SUBJECT: Addendum No. 2
Hamilton County Water and Wastewater Treatment Authority (WWTA)
West Brow Oval Pump Station Improvements/WWTA Project #12-316
(SWIG ID: 2022-8571, Project WW-PDC-1)

ADDENDUM NO.2
WEST BROW OVAL PUMP STATION IMPROVEMENTS
HAMILTON COUNTY WWTA
WWTA PROJECT NO.12-316
(SWIG ID: 2022-8571, PROJECT: WW-PDC-1)
CTI PROJECT NO. C22044

I. CONTRACT DRAWINGS

JOB NO. C22044
ISSUE DATE 12/19/2023
DRAWING NO. C-002.3

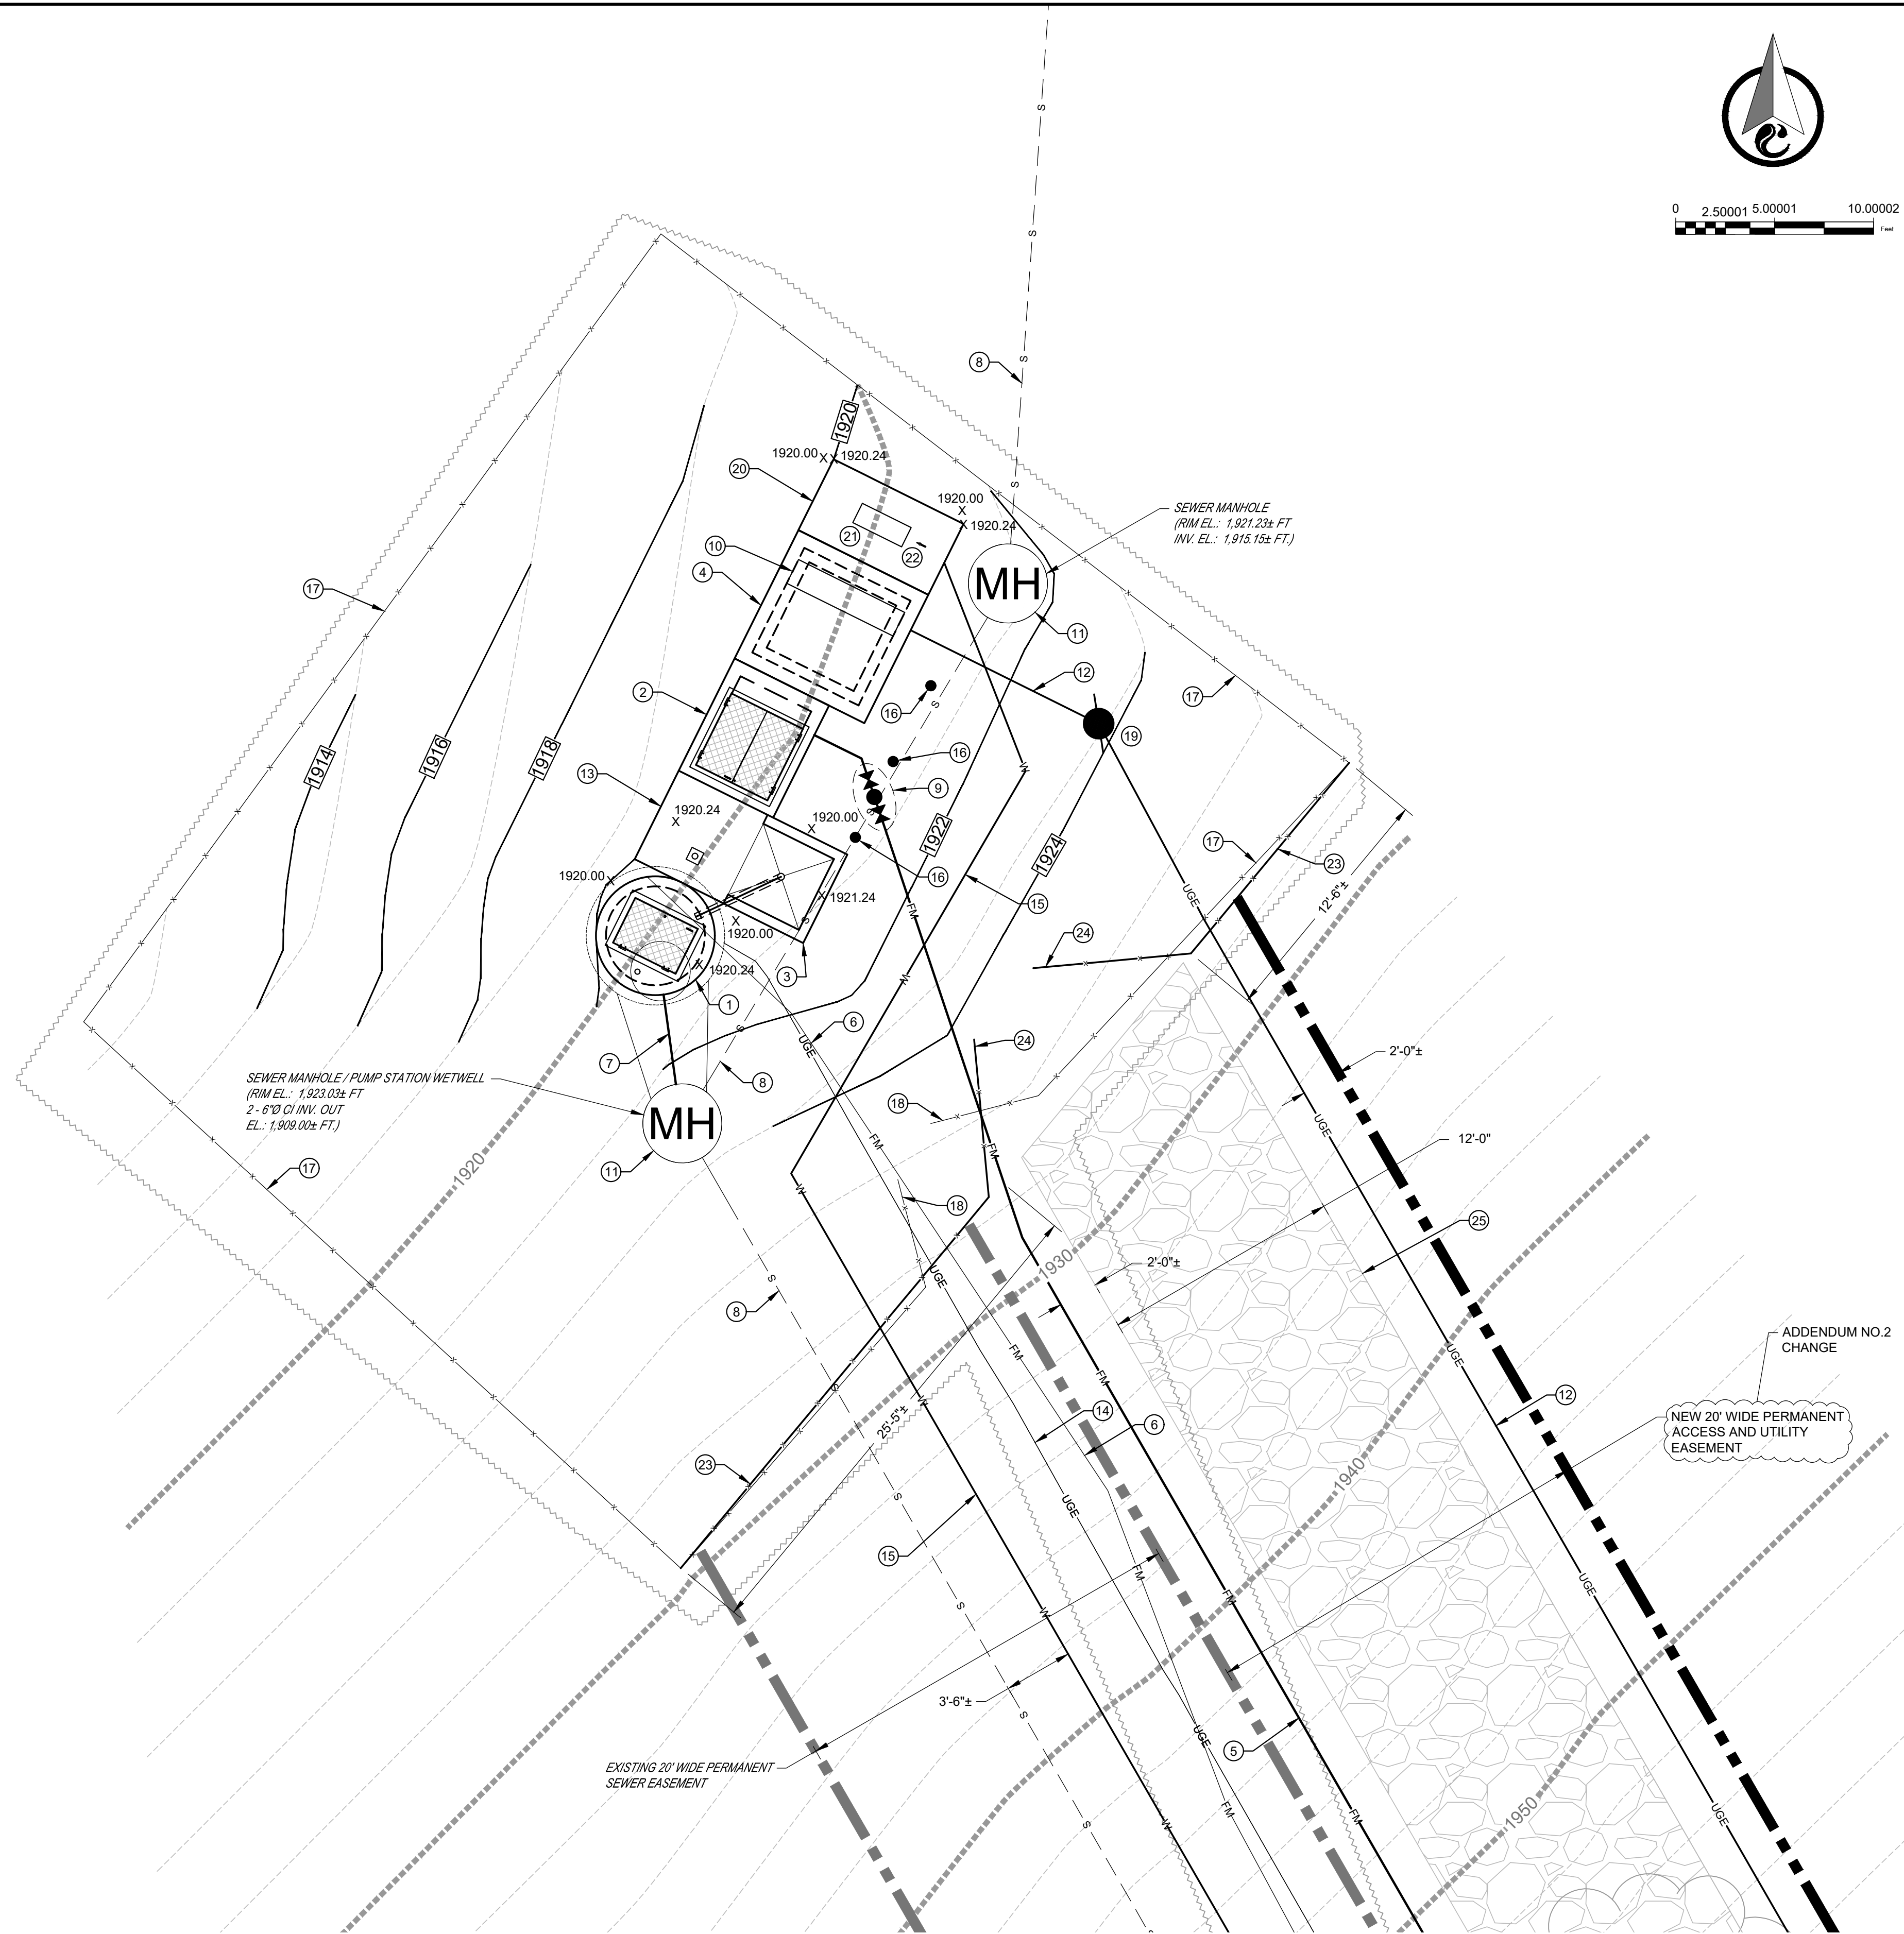
- A. *Drawing G-001.3.*** DELETE the drawing in its entirety and SUBSTITUTE therefore the attached Drawing G-001.4.
- B. *Drawing C-002.2.*** DELETE the drawing in its entirety and SUBSTITUTE therefore the attached Drawing C-002.3.
- C. *Drawing C-003.3.*** DELETE the drawing in its entirety and SUBSTITUTE therefore the attached Drawing C-003.4.
- D. *Drawing C-004.3.*** DELETE the drawing in its entirety and SUBSTITUTE therefore the attached Drawing C-004.4.
- E. *Drawing E-001.2.*** DELETE the drawing in its entirety and SUBSTITUTE therefore the attached Drawing E-001.3.

NO.	DESCRIPTIONS	REVISIONS		
		DATE	BY	APPD
1	REDUCED VALVE VAULT SIZE	02/24	DDT	DDT
2	REVISED UTILITIES/ACCESS RD RTE	03/24	DDT	DDT
3	REV PERMANENT EASEMENT LABEL	05/24	DDT	DDT

JOB NO.
 C22044
 ISSUE DATE
 12/19/2023
 DRAWING NO.
 C-004.4

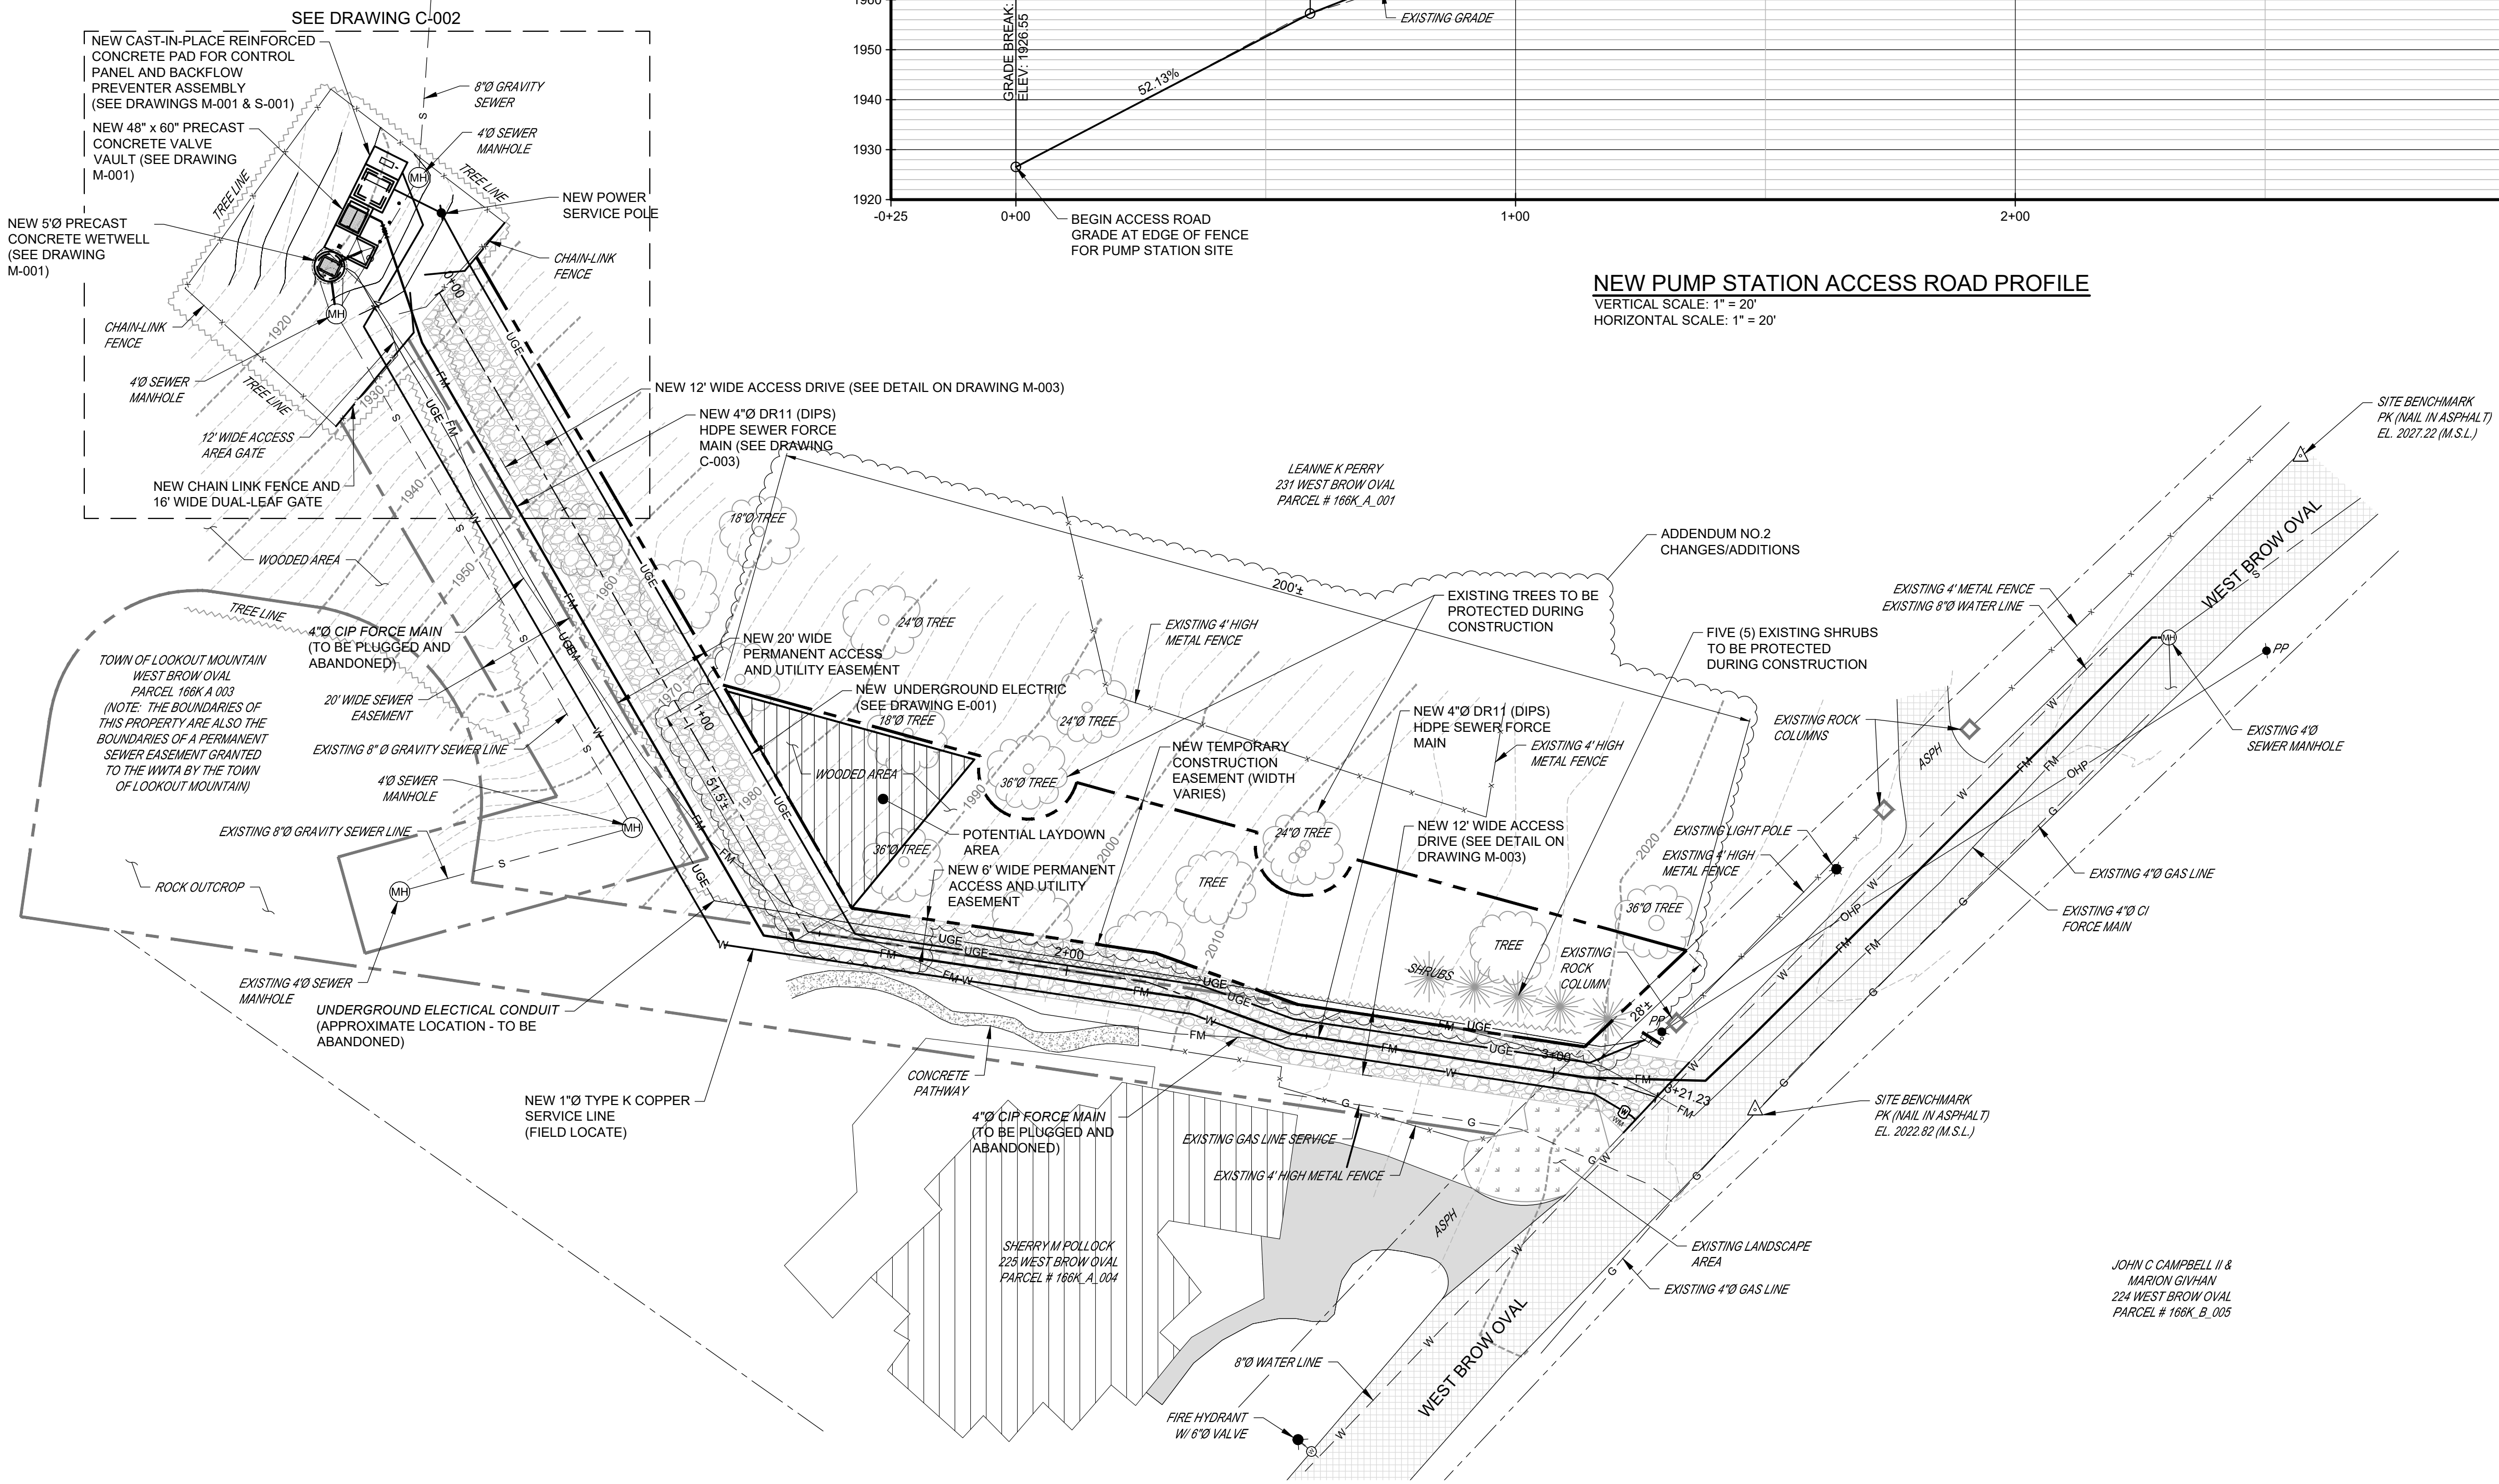
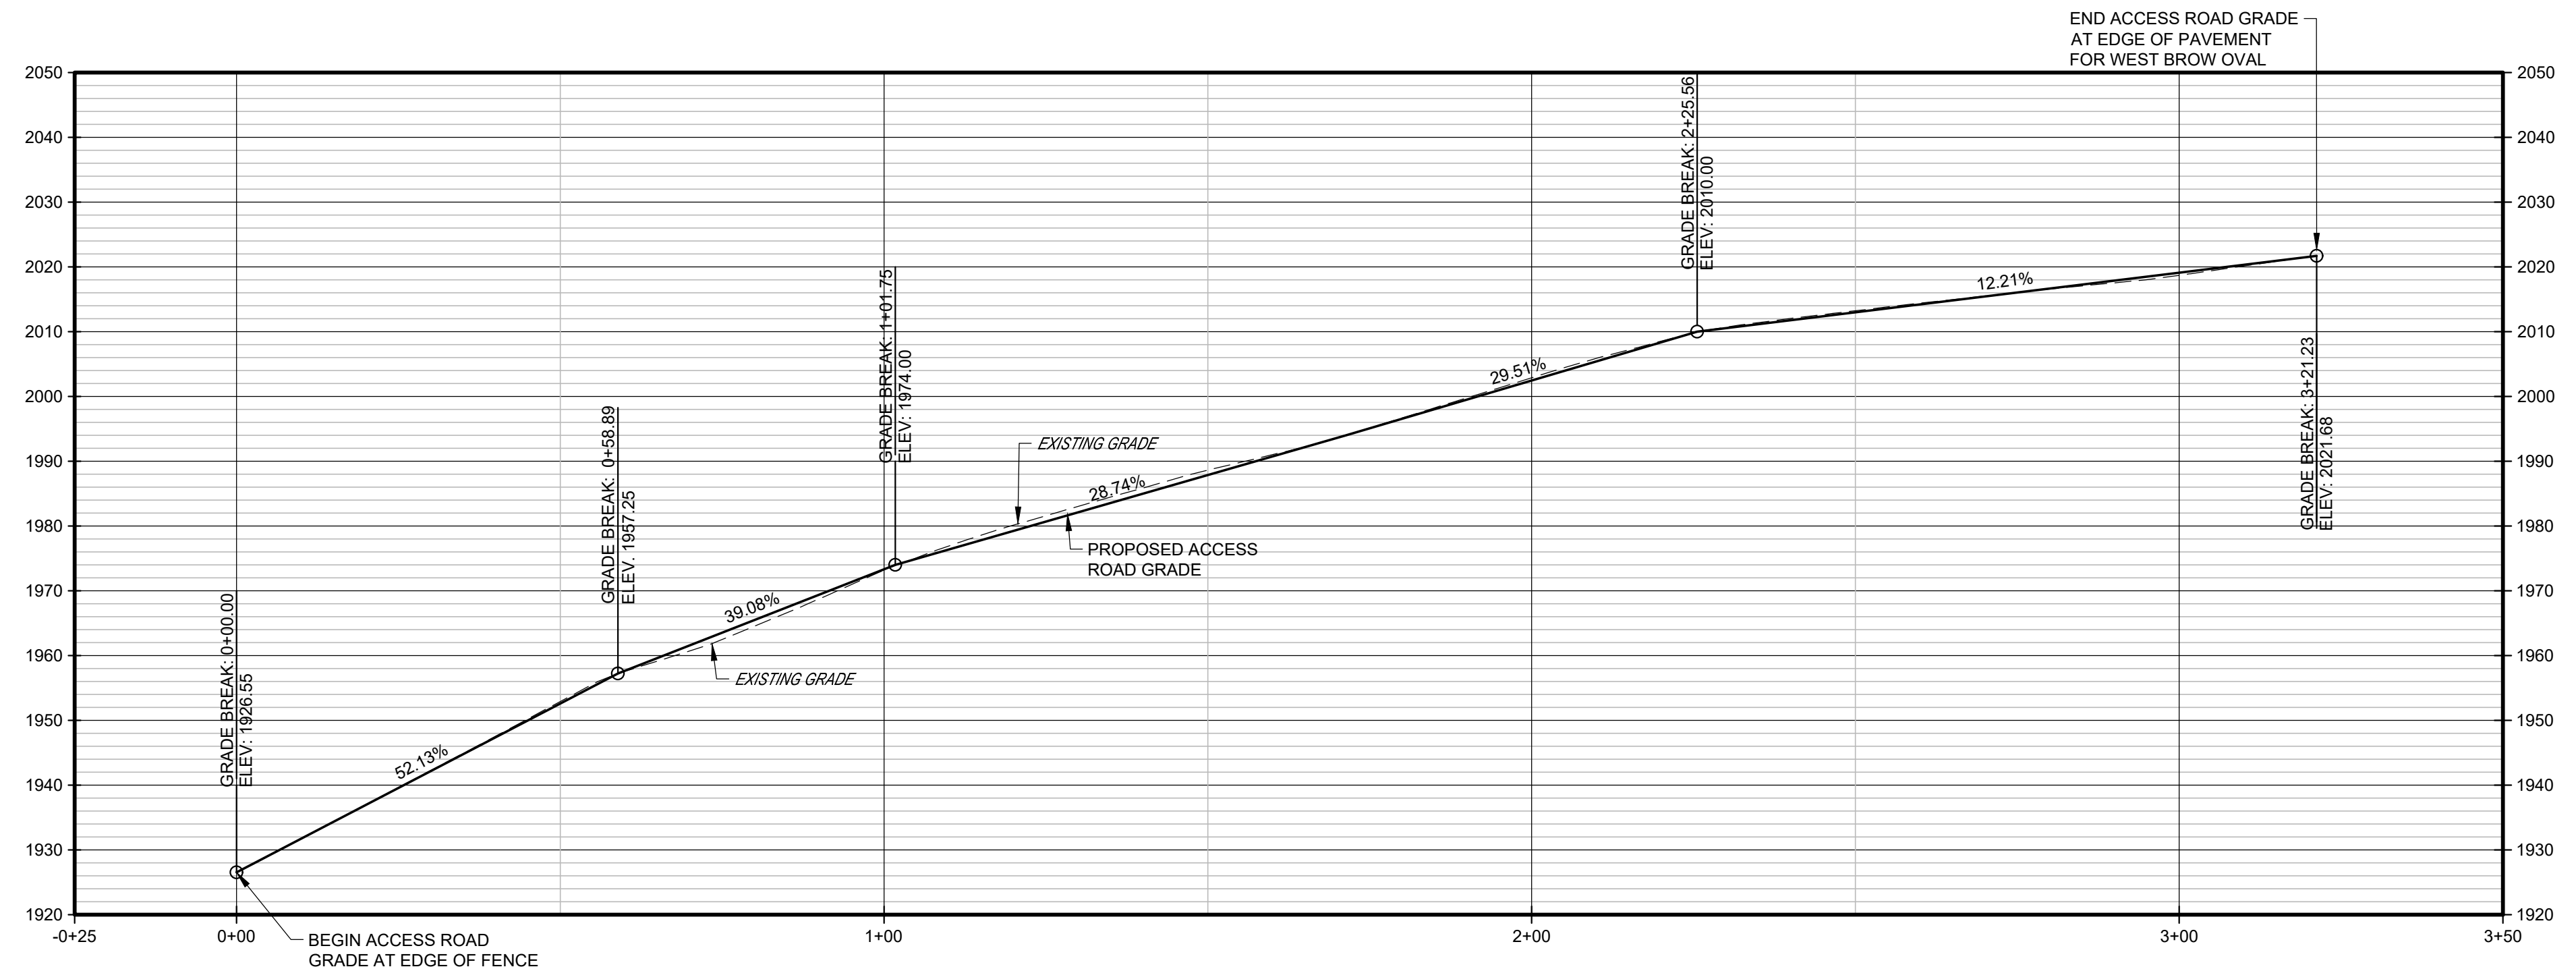
DESIGN		REVISIONS			
RWJ	DDT	NO.	DESCRIPTIONS	DATE	BY
DDT	DDT	1	MODIFIED DRAWING NAME	01/24	DDT
DDT	DDT	2	REDUCED VALVE VAULT SIZE	02/24	DDT
DDT	DDT	3	REVISED PS ACCESS ROAD RTE	03/24	DDT
DDT	DDT	4	ADDED TEMP CONSTR EASEMENT	05/24	DDT
